Re: Petition No. 1558 - Community Power Group LLC petition for a declaratory ruling, pursuant to Connecticut General Statutes §4-176 and §16-50k, for the proposed construction, maintenance and operation of a 4-megawatt AC solar photovoltaic electric generating facility located at 24 Middle Road, Ellington, Connecticut, and associated electrical interconnection.

Enclosed for filing with the Connecticut Siting Council ("Council") are Community Power Group LLC's ("CPG" or the "Company") responses to the Council's second set of interrogatories dated April 6, 2023.

24 MIDDLE - ELLINGTON SOLAR PROJECT
4.0 MW ARRAY

SINGLE LINE DIAGRAM

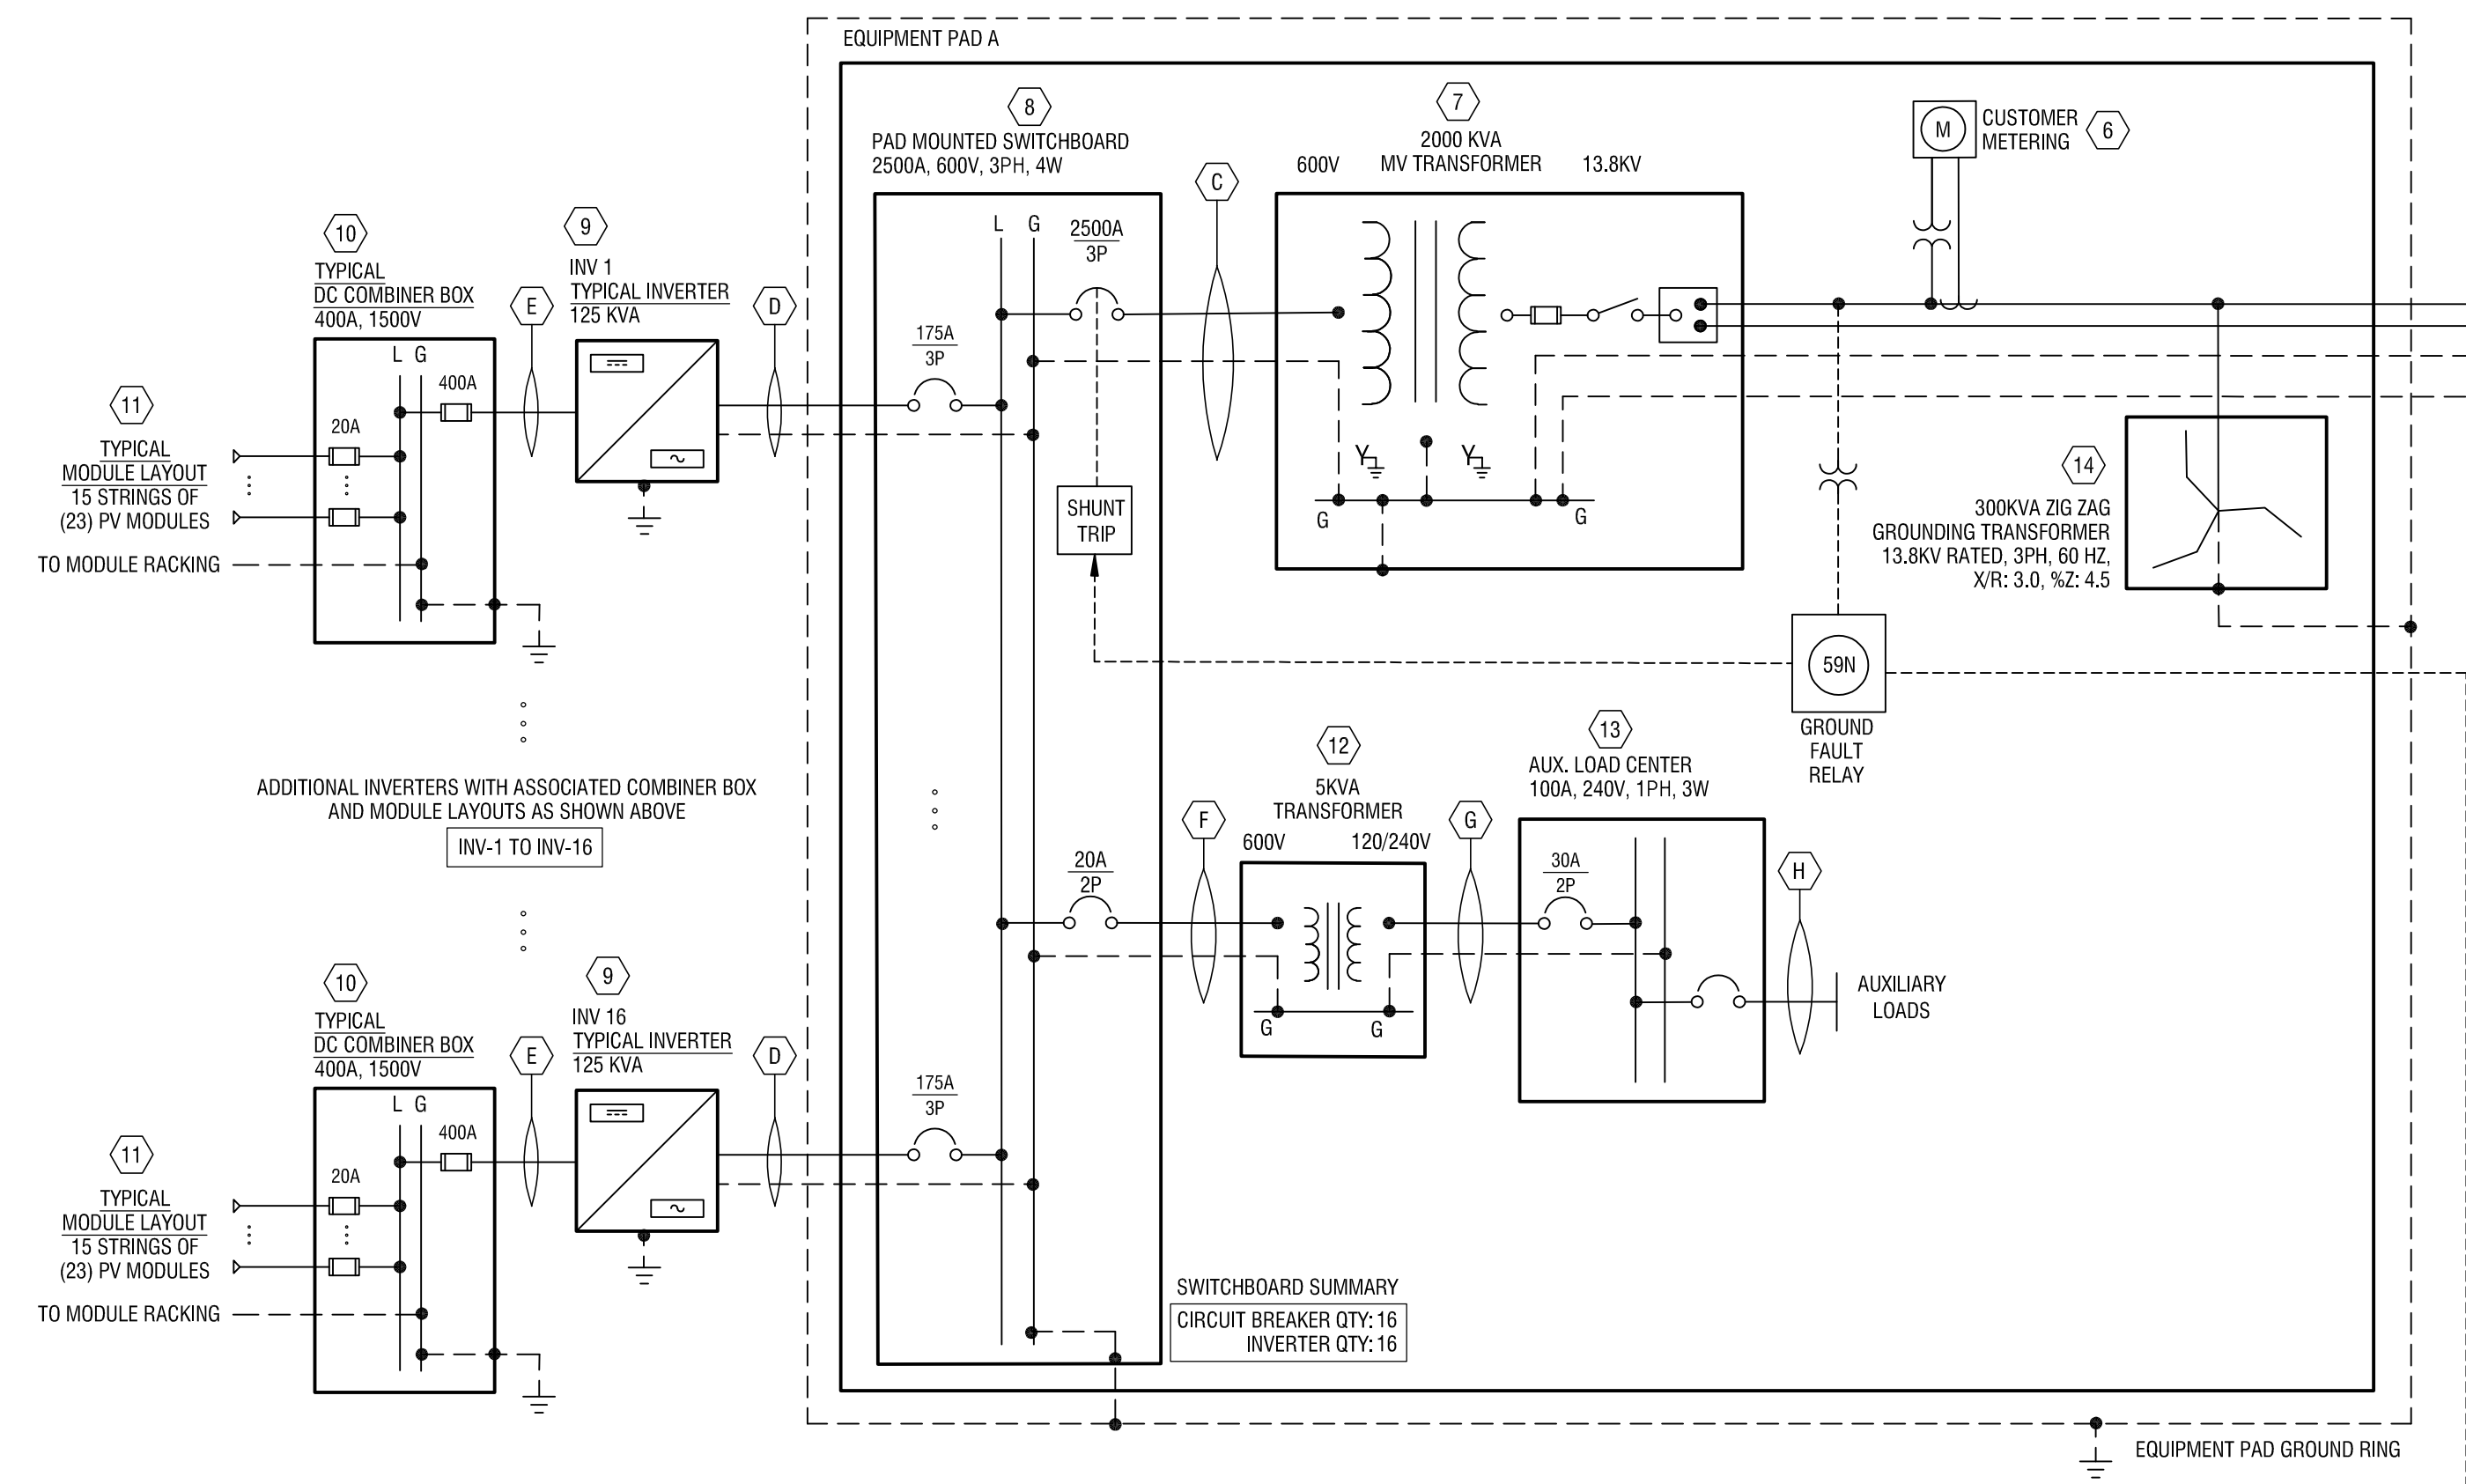
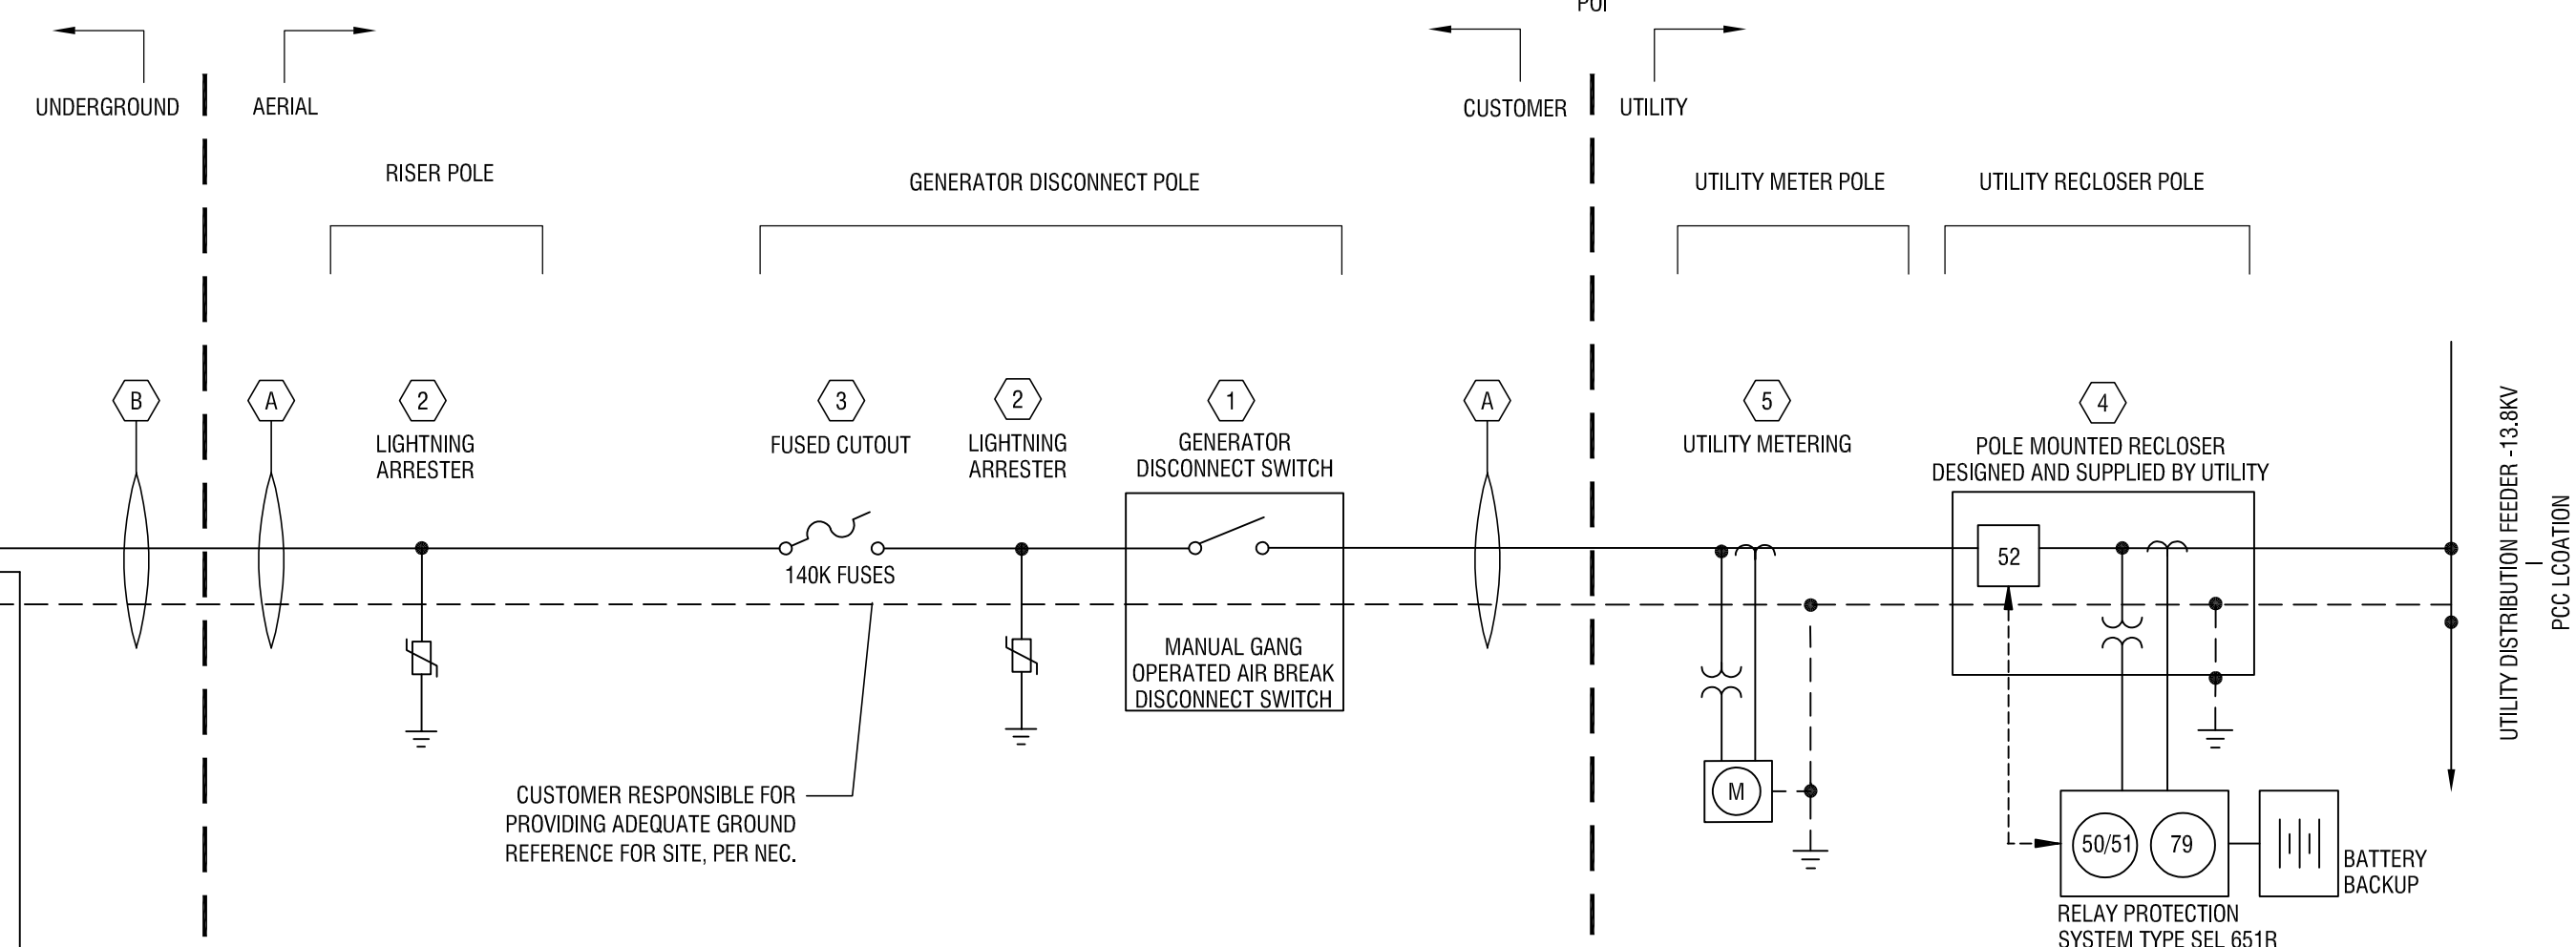
Q-CSC-47: Provide a one-line diagram of the interconnection facilities identifying both overhead and underground equipment.

A-CSC-47: Please see Exhibit CSC-47-1.
